PHOTOGRAPHS

PHOTOGRAPH #3

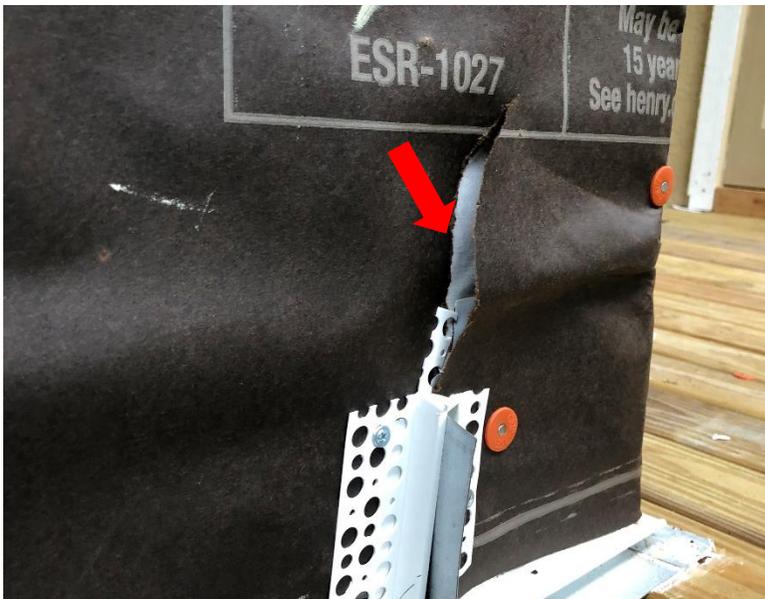
Holes and tears in Super JumpTex shall be covered with Tyvek tape prior to lath installation.

PHOTOGRAPH #7

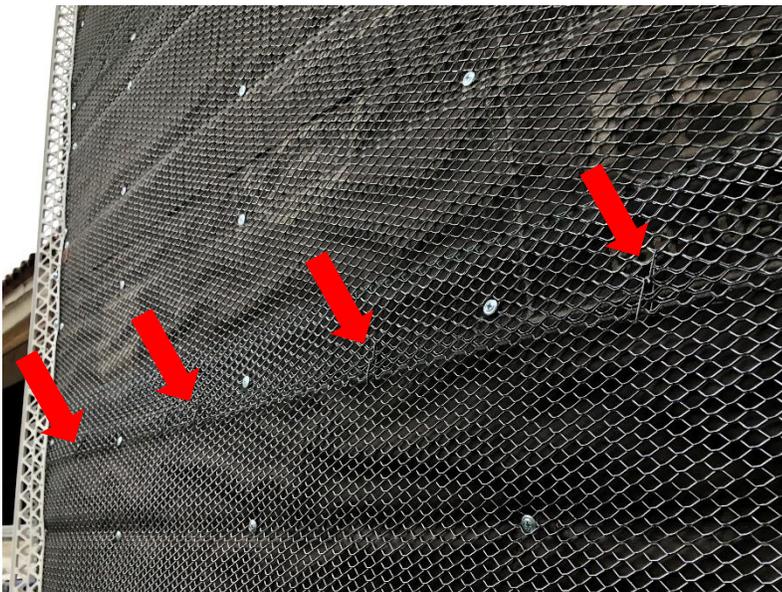
Kickout flashing and accessories have been installed with the flashing lap backwards. Contractor to fix flashing lap.
